# Technical Note

<b>Project</b>	Plots 23-26, The Oxford Science Park	<b>Project No</b>	13886
<b>Subject</b>	Section 73-Undercroft Amendments	<b>Date</b>	6 December 2023
<b>File Ref</b>	13886-CRH-ZZ-XX-TN-C-0004-P1_TN-Undercroft Removal.docx	<b>Pages</b>	10

This Technical Note has been prepared in support of a Section 73 amendment application and discharge of condition application to Plots 23-26 of Oxford Science Park to discuss changes made to the undercroft across the proposed development and the impact this change has on both the proposed site surface water drainage strategy and flood risk. The original planning application was submitted to Oxford City Council in September 2022 ref. 22/02168/FUL

**Proposed Drainage Layout Sheet 2 of 4**

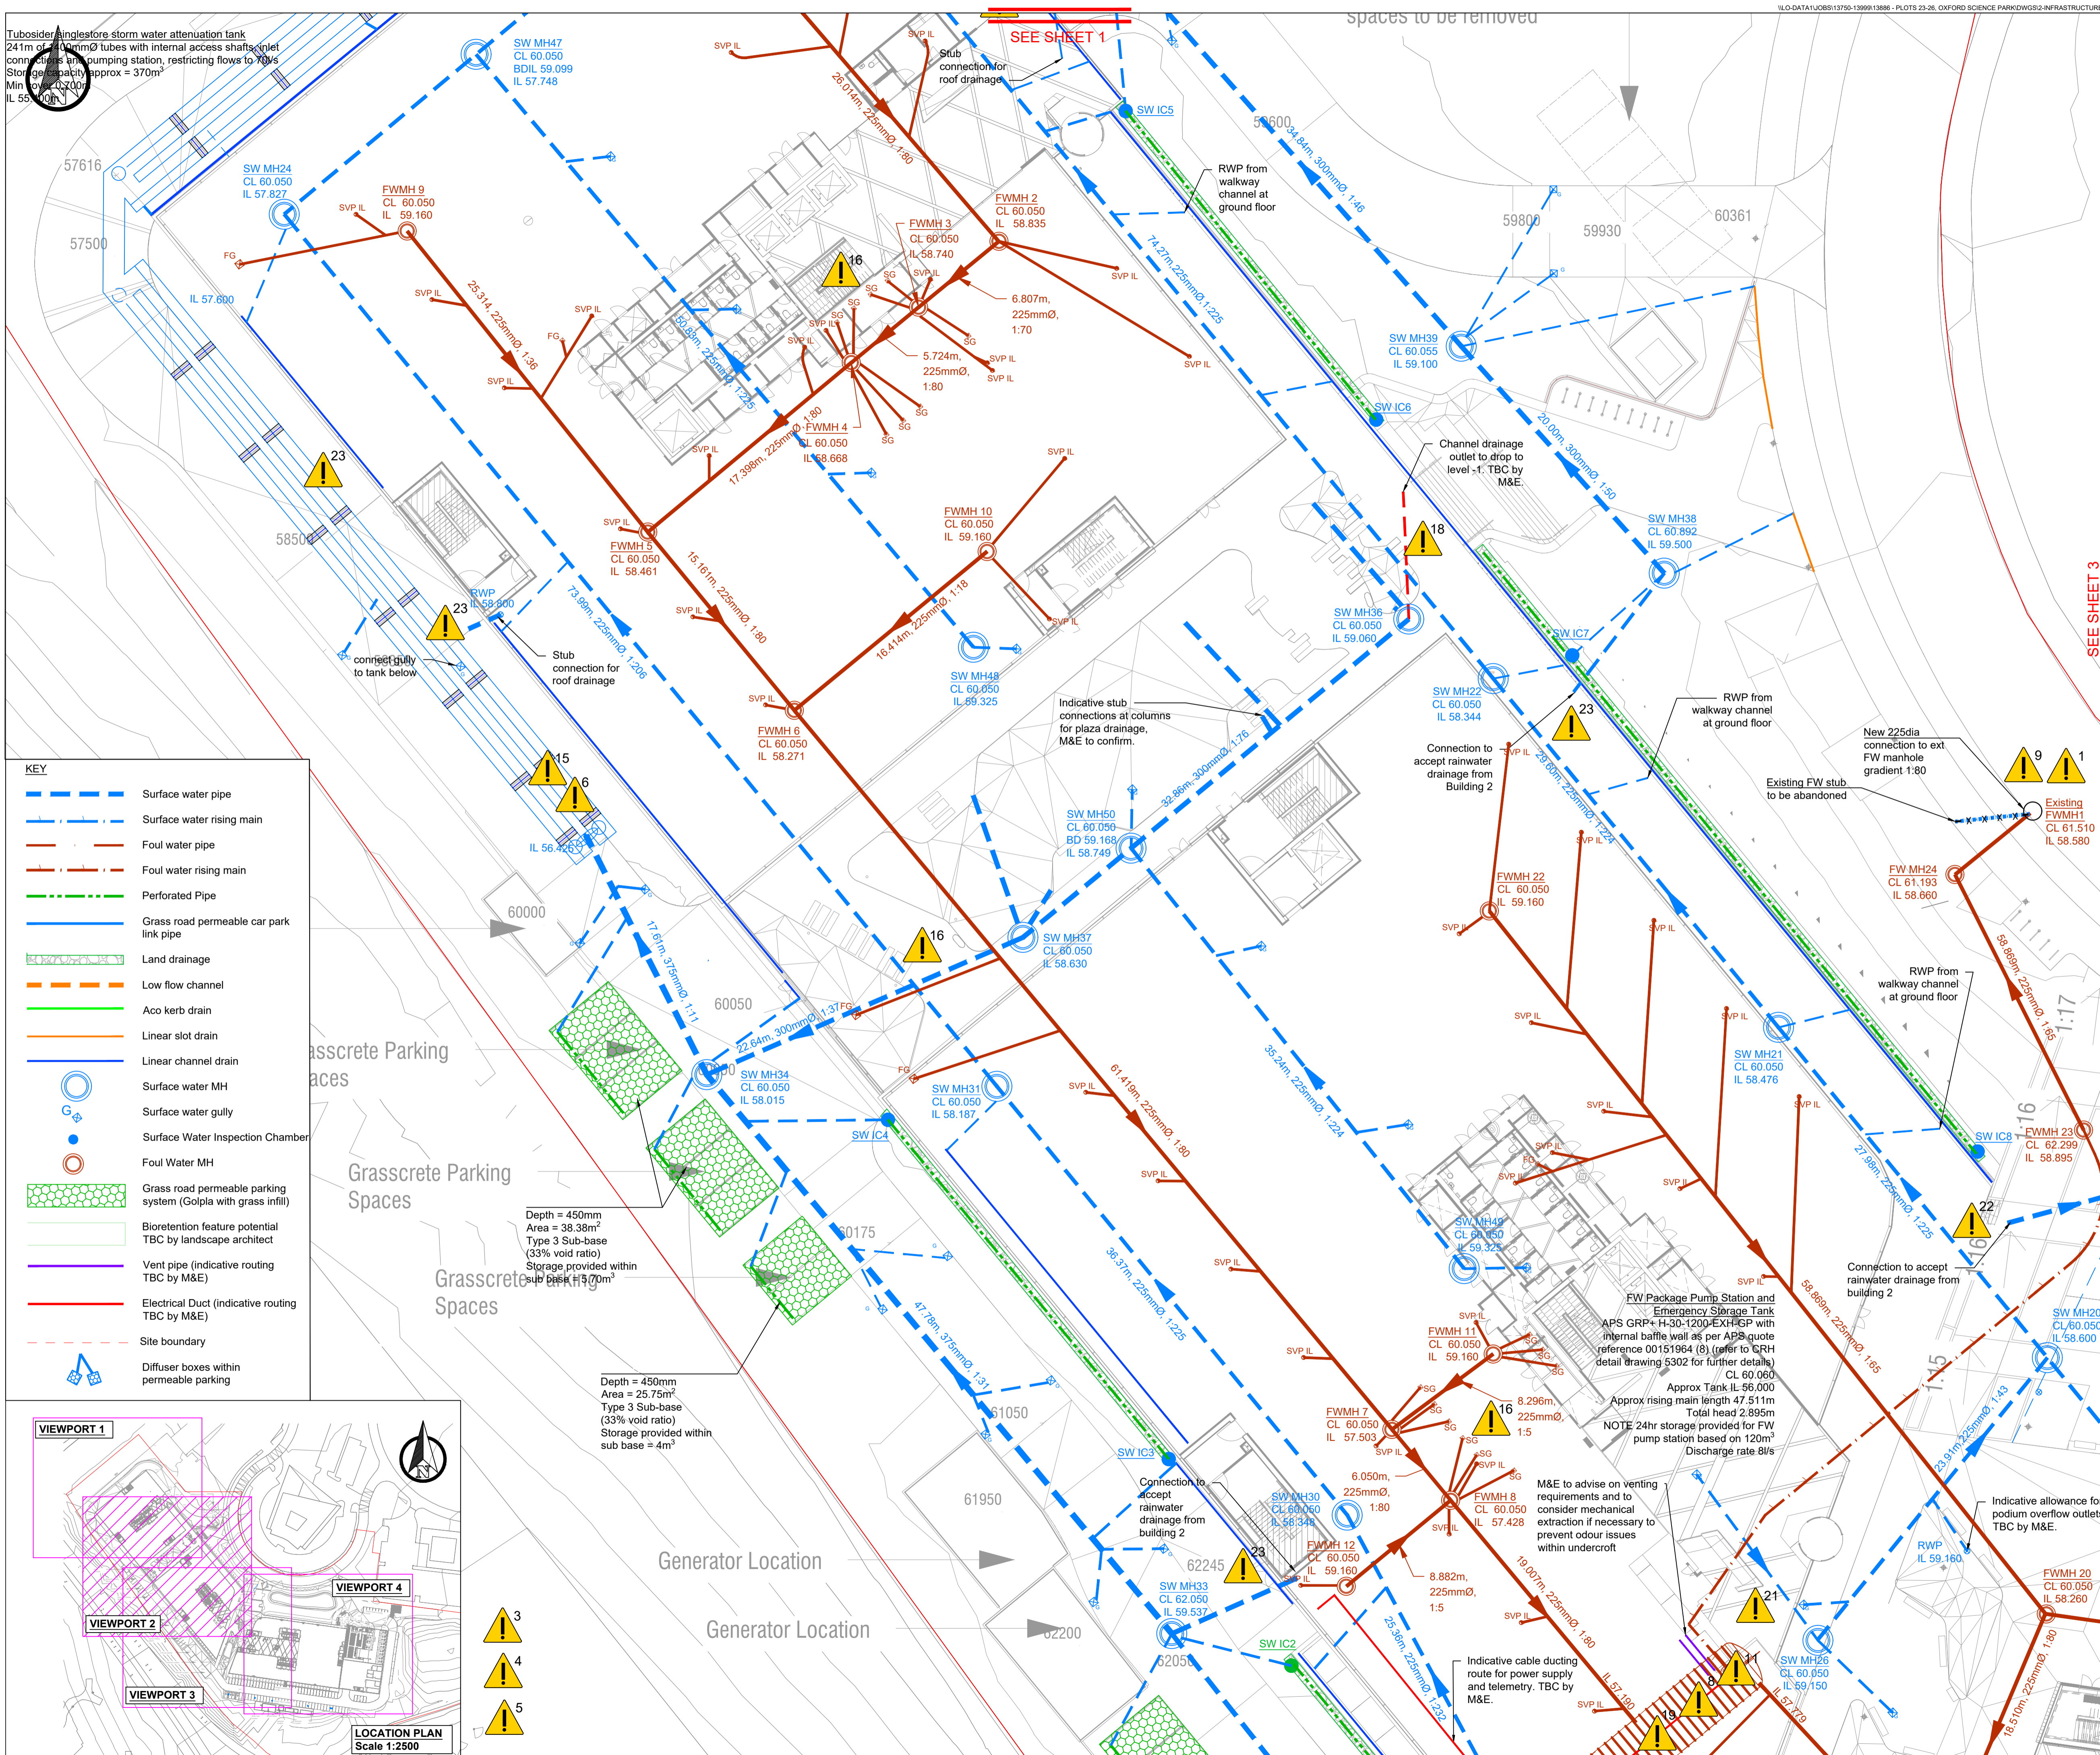
As the foul drainage system relies on a pumped connection to the existing private foul drainage system the changes required were minimal and predominantly comprised minor amendments to the main drainage runs along with the realignment of the foul branch connections to align with the updated pop-up locations. Therefore, it can be concluded that the FW drainage strategy remains unchanged and aligns with what was set out in the approved flood risk assessment for the site ref. 13886-CRH-ZZ-XX-RP-C-0002-P2.

Changes to the surface water drainage system are also minimal as the changes to the scheme associated with the undercroft amendments do not affect the proposed surface water catchment areas and discharge locations. For full details of the site surface water drainage strategy along with catchment splits and discharge rates into the wider site drainage system please refer to the following approved documents:

- 13886-CRH-ZZ-XX-DR-C-5057-P1-Proposed Drainage Strategy
- 13886-CRH-ZZ-XX-DR-C-5058-P1-Proposed Drainage Strategy
- 13886-CRH-ZZ-XX-DR-C-5059-P1-Proposed Drainage Strategy
- 13886-CRH-ZZ-XX-DR-C-5060-P1-Proposed Drainage Strategy
- 13886-CRH-ZZ-XX-DR-C-5400\_P2 RPZ Overlaid on Drainage Layout (Sheet 1 of 2)
- 13886-CRH-ZZ-XX-DR-C-5401\_P2 RPZ Overlaid on Drainage Layout (Sheet 2 of 2)

**RPZ Overlaid on  
Drainage Layout  
Sheet 1 of 2**

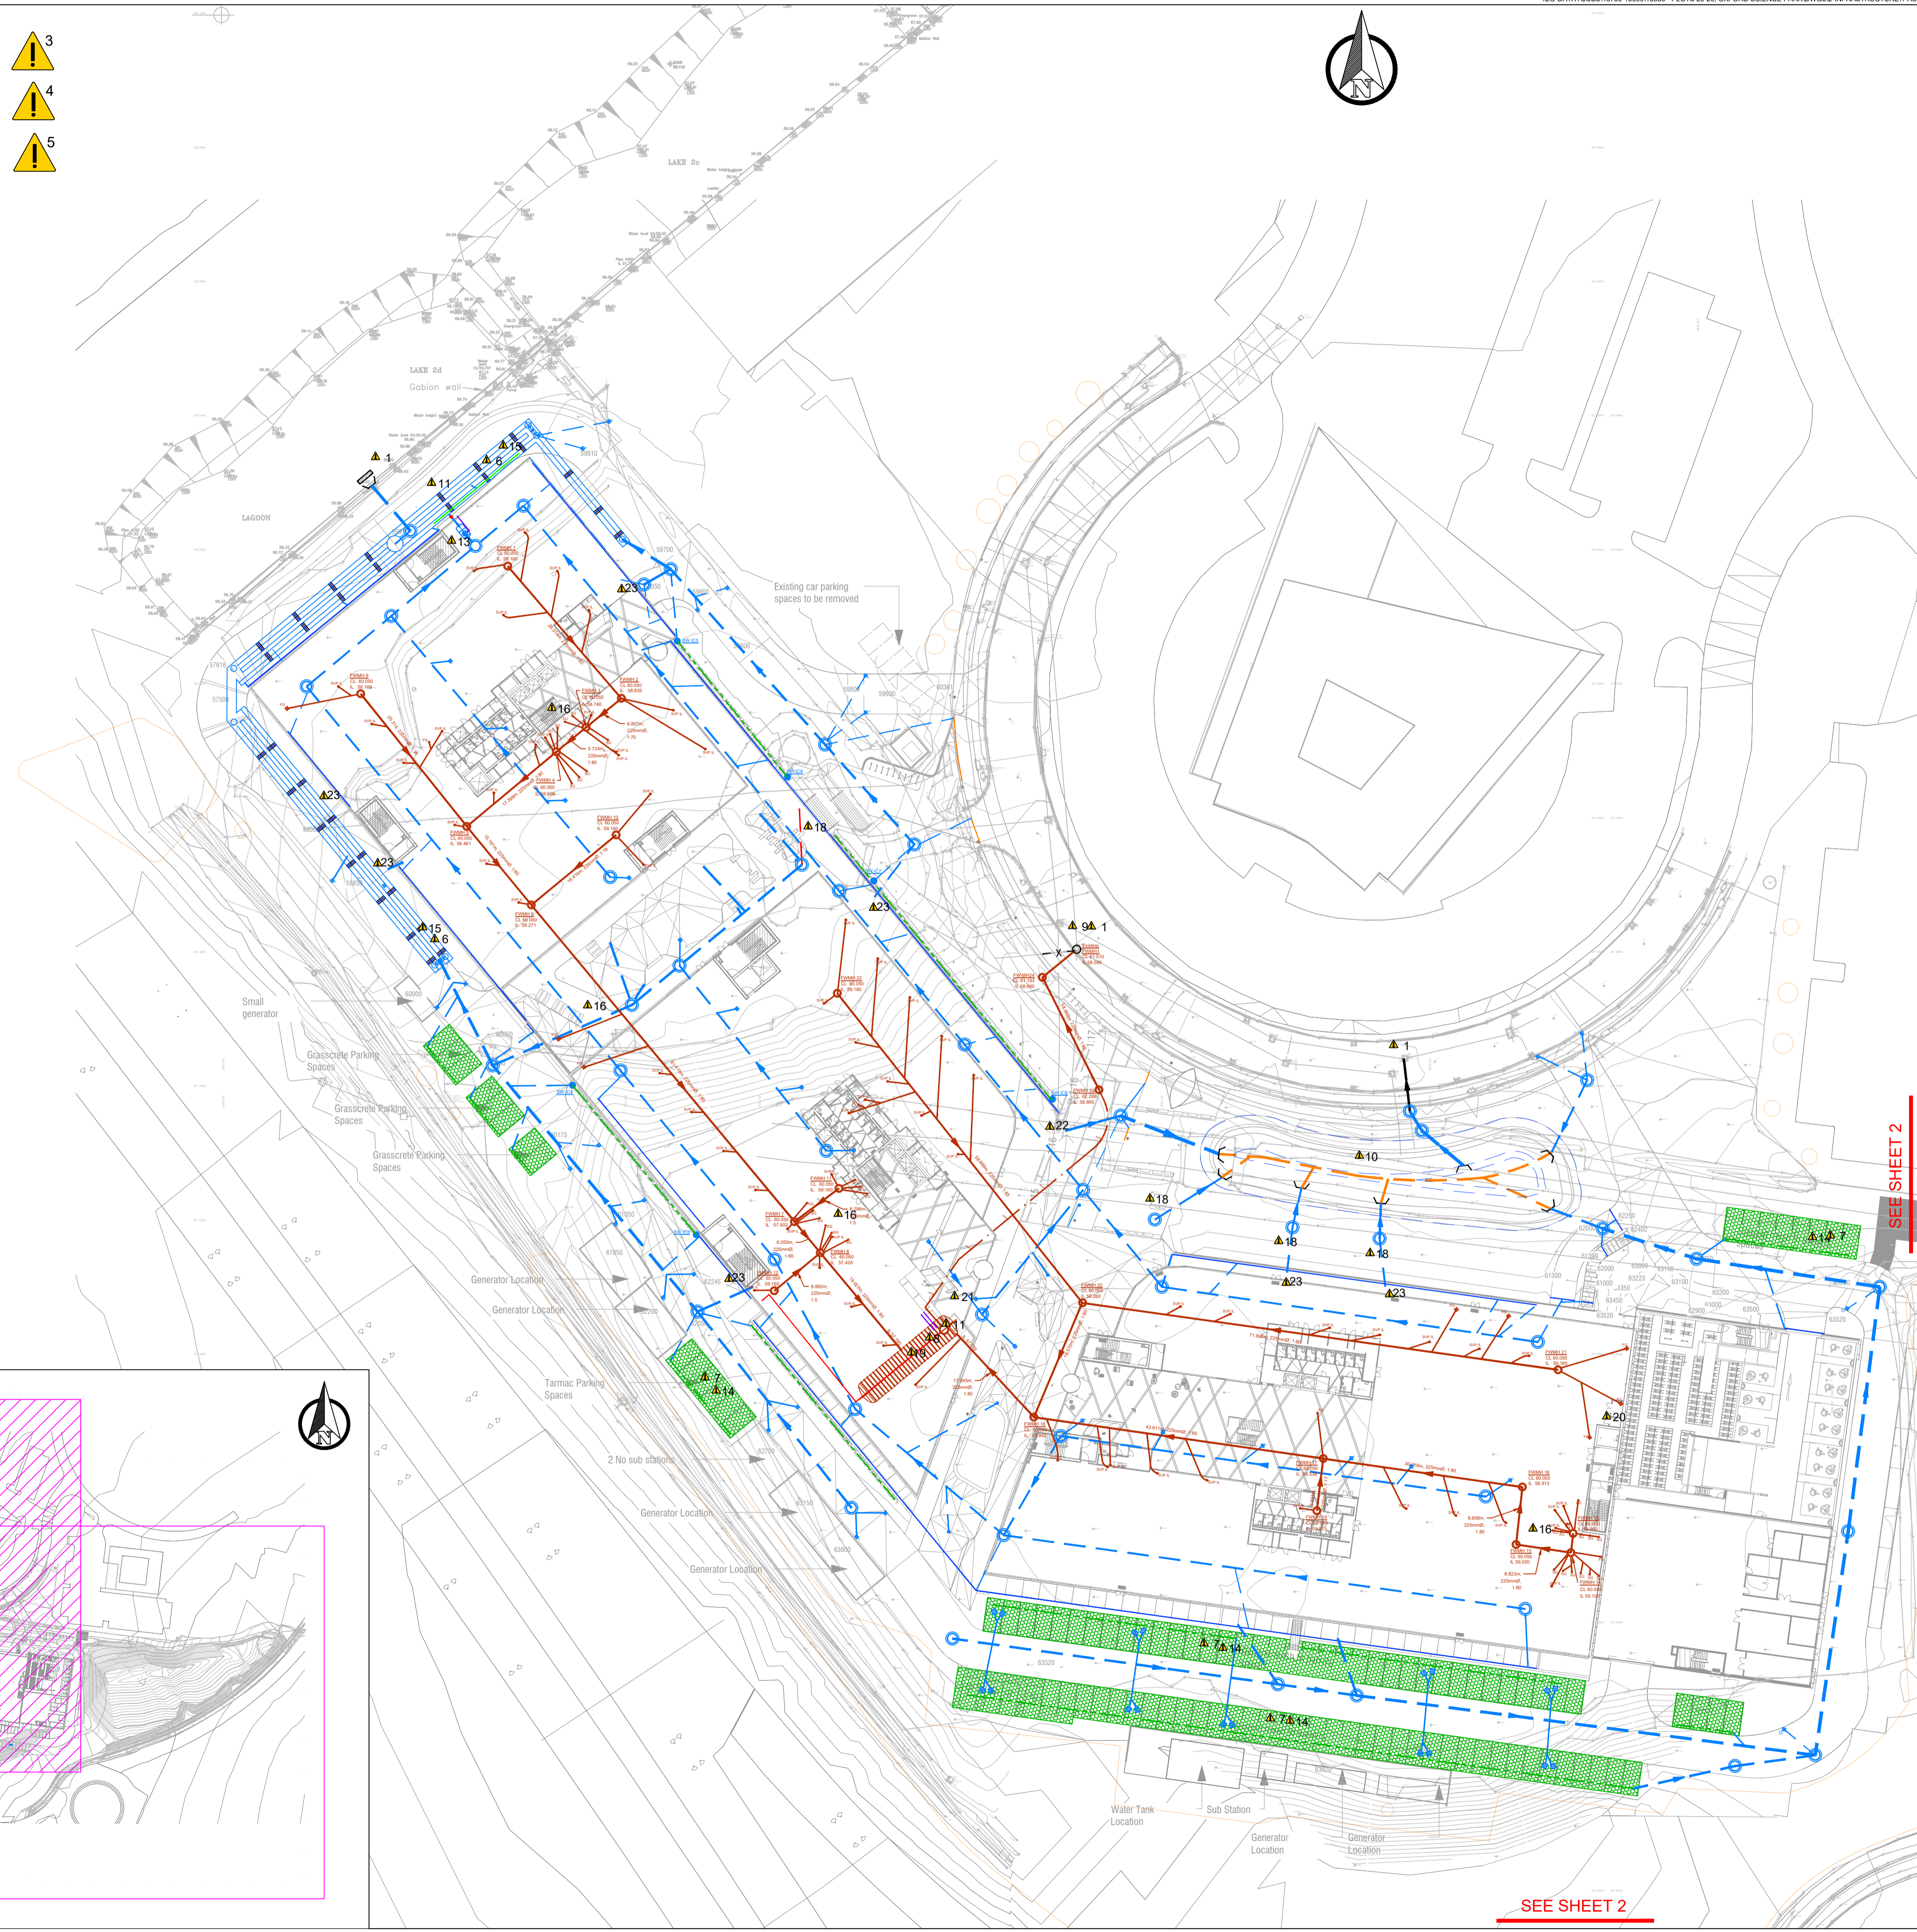
P2	Drainage Updated	05/12/23	ZA
P1	Issued for information	22/02/23	IC
Rev	Description	Date	By
